3023932

740 HARVARD AVE E | SEATTLE WA 98102

RECOMMENDATION MEETING

MEETING DATE: DECEMBER 12TH, 2018

**Street Elevation**

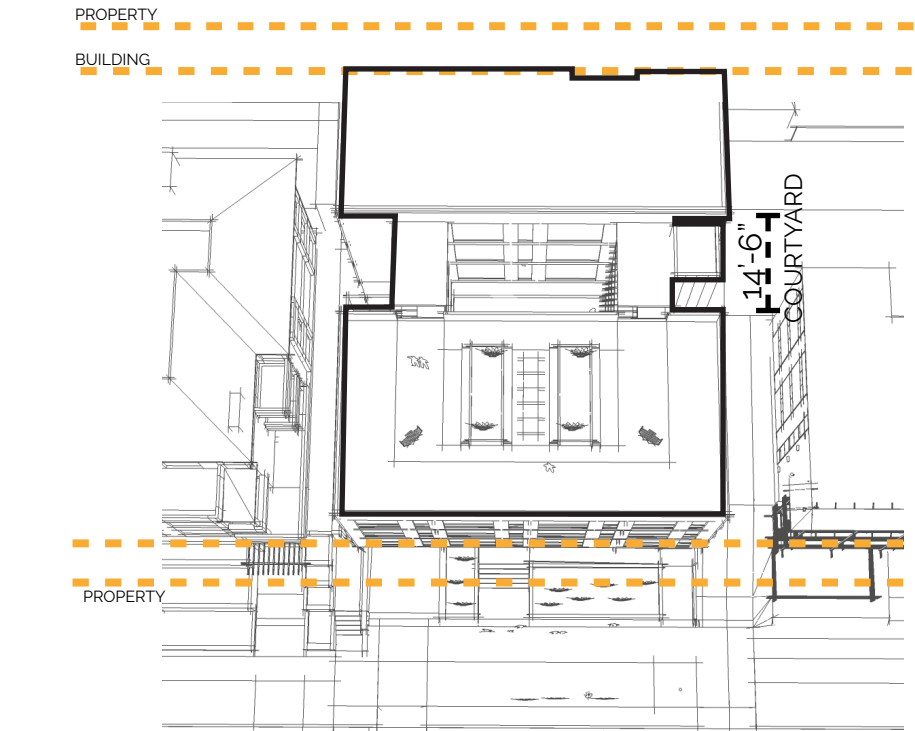
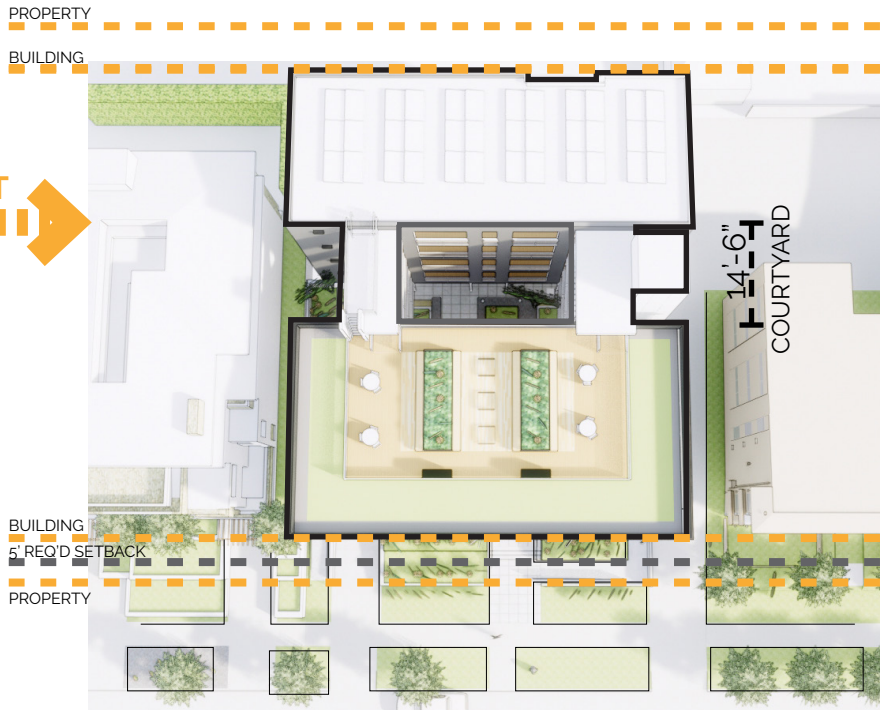
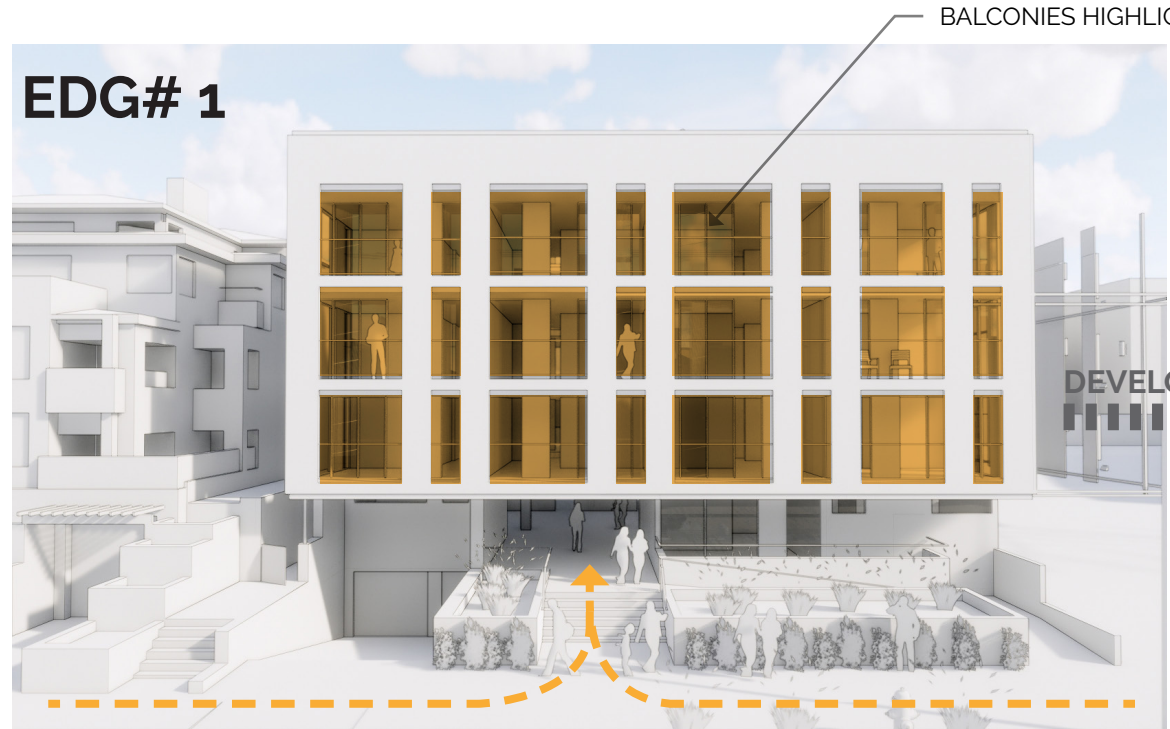
The board commented that Option #3, the **Open court** Option, was the strongest concept, echoing public comment. Strengths were the **lower front massing** and **balconies** on the street. The proposed **setback from the street** was also important to retain as shown to meld with the neighboring building setbacks for a **good street building face**.

a. The Board commented that Option #3, the Open Court option, was the strongest concept presented at the meeting, echoing public comment. It pointed out the strengths of the lower front massing, balconies on the street and higher rear massing and directed the applicant to develop Option #3 going forward. (CS2A2, CS2D1,2,5)

b. The Board agreed that the proposed setback from the street was important to retain as shown to meld with neighboring building setbacks for a good street building face. (CS2B1, PL2 I, CS3A1)

Option #3 has been maintained and is represented as the scheme in the MUP plans.

The massing has been lowered along the front part of the building and balconies have been maintained along the street edge.

*Front setback increased, maintained.*

RESPONSE TO EDG | SECTION 2: RELATIONSHIP TO THE STREET

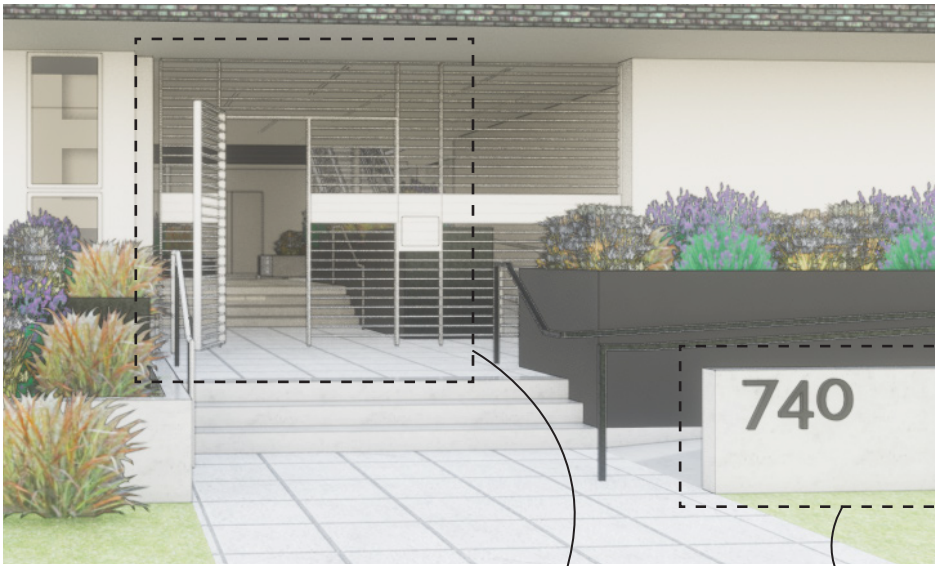
The board **approved the entry sequence** and asked that the **gate** at the courtyard be pushed back to leave the entry area **open and inviting** and not look like a barrier. The trash adjacency next to the entrance and bicycle parking in the garage were approved.

e. The Board approved of the entry sequence and asked that the gate at the courtyard be pushed back as far as possible to leave the entry area open and inviting and the gate element to meld with the design and not look like a barrier. (PL2I, PL2B1)

f. The Board agreed with public comment and approved the trash room location and functional explanation. (DC1Ilii)

g. The Board was supportive of an easily accessible bicycle room and simple access to it via the ramp or stairs with a rill (a shallow channel) for bike tires. (PL4B)

Response: The project has moved forward with the preferred entry sequence and the entrance was kept wide to maintain visibility into the courtyard beyond and out towards the street. In order to maintain security, relate to the datum established at the lower level, and maintain a visual relationship between the gate at the driveway and the gate at the entrance, the fence was kept in the current location. Both of the garage gate and entry gate shall be constructed out of thin steel members and painted white to allow for minimal visual obstructions.

The trash room location has been maintained at the southwest corner of the building and shall be enclosed within the structure. It will be close enough to the street that the trash contractors can come get the trash and return it to the room without needing to leave it in the right of way.

Response: Bicycle storage is located in the parking garage and can be easily accessed by the ramp down to the garage or internally via the building's elevator. This location is preferred for its safety and security and to not hinder the paths of egress on the main level.

Elevator location has minimal impact on the neighbors

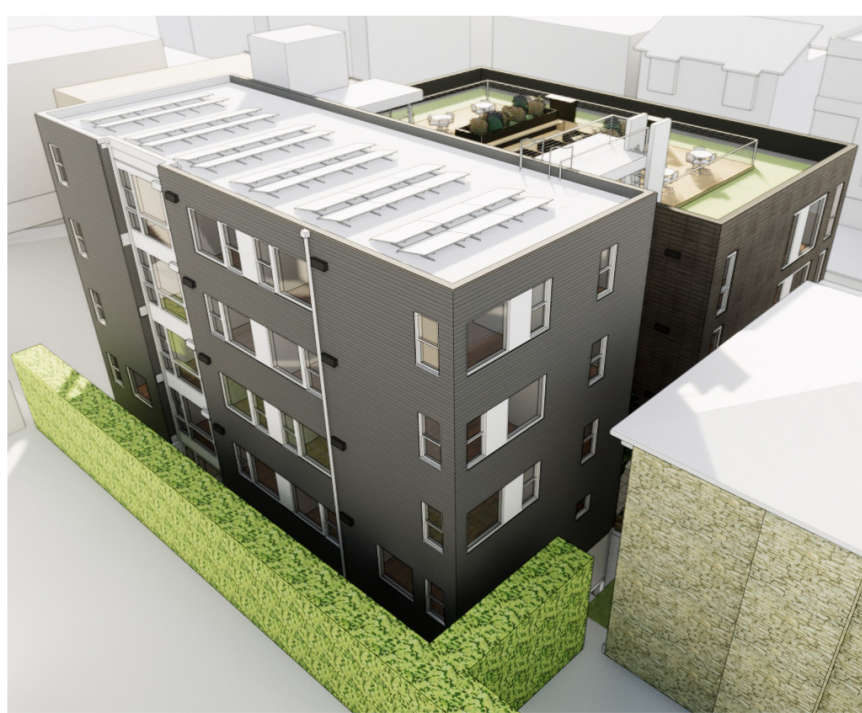
The board affirmed keeping the large hedge at the rear property line to maintain a sense of privacy. The elevator was approved in the location shown which minimizes the penthouse impact on neighboring sites.

c. The Board affirmed the applicant's suggestion to keep a large hedge at the rear property line for a sense of privacy for both sites. (DC4D1)

d. The Board approved of the elevator location which helps minimize the elevator penthouse impact on neighboring sites. (CS2D4)

The overall health and viability of the hedge will be maintained. Furthermore, planting will be added along the northern property line to increase the privacy to the adjacent condo building to the north and windows have been minimized at the ground floor units facing south to maintain privacy along the driveway of the adjoining south apartment building.

The elevator location was maintained on the south side of the building to help reduce shadows cast on the adjacent property to the north.

Courtyard looking at main entrance

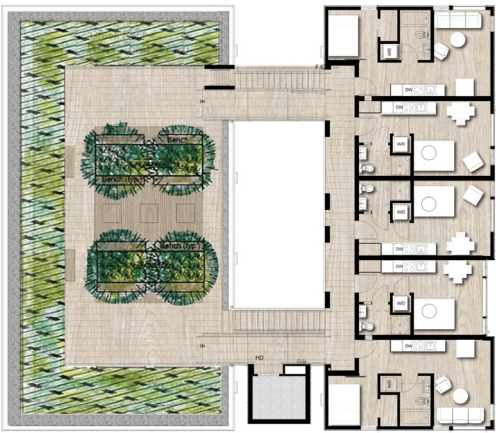
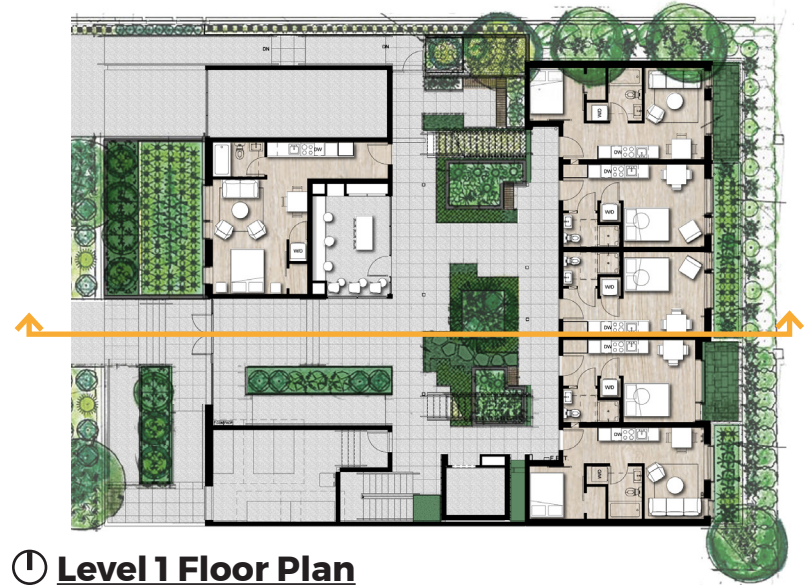
The board requested “quiet” colors for the courtyard and keen use of quality materials. The courtyard should also be well-designed and provide useable space for the residents. The roof should support and provide small gathering areas as an amenity.

a. The Board requested “quiet” colors for the courtyard and keen use of quality materials. They also asked for a well-designed and useable space for the residents in the courtyard. (DC4A1, Cs31)

b. The Board requested the applicant continue with the concept to provide small gathering areas at the roof top amenity space. (PL1C1)

The courtyard will feature brick on the west facing mass and lap siding on the east facing mass. These two colors will be complimentary and shall lend the quiet atmosphere that was mentioned at the EDG meeting. Benches are scattered throughout the courtyard and a landscaped nook has been designed to the north. A mail room adjacent to the courtyard provides additional seating and lounge space for residences.

The roof deck plan, which has been pulled back from the façade of the building, has been divided into smaller gathering areas for more intimate interactions rather than one large open roof deck.
